Comprehensive Park Master Plan Update for Foothill Community Park

The District received these questions from Vendors that expressed an interest in the RFQ for the Comprehensive Park Master Plan Update for Foothill Community Park:

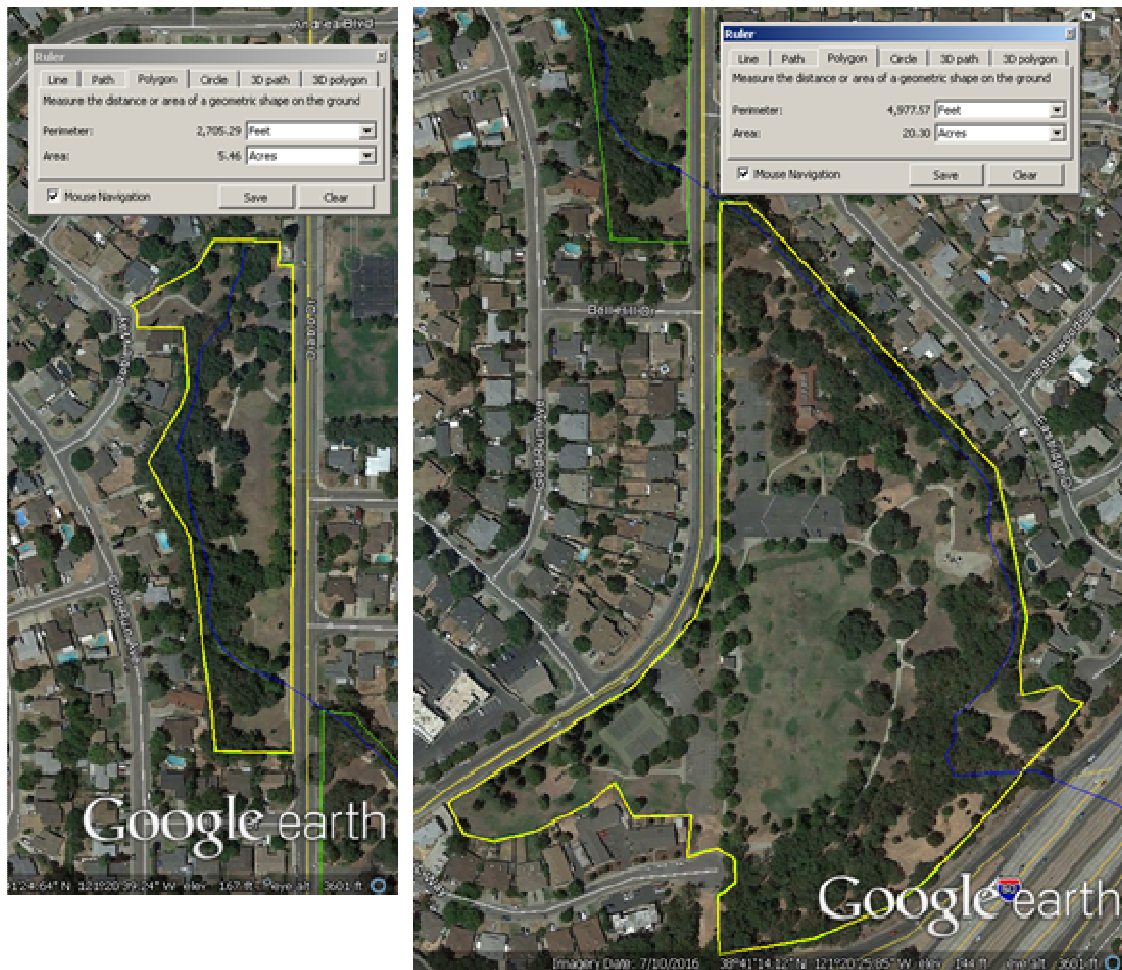
- 2.) It appears that the District is intending to have a master plan completed for the entire 25 acres, but describe in the RFQ that most of the intended improvements are focused on the southern portion of the site. For purposes of this response are we to scope out for master planning for the entire 25 acre parcel? ***District Response - Yes the entire park is to be included. See Diagram above outlined in Yellow.***
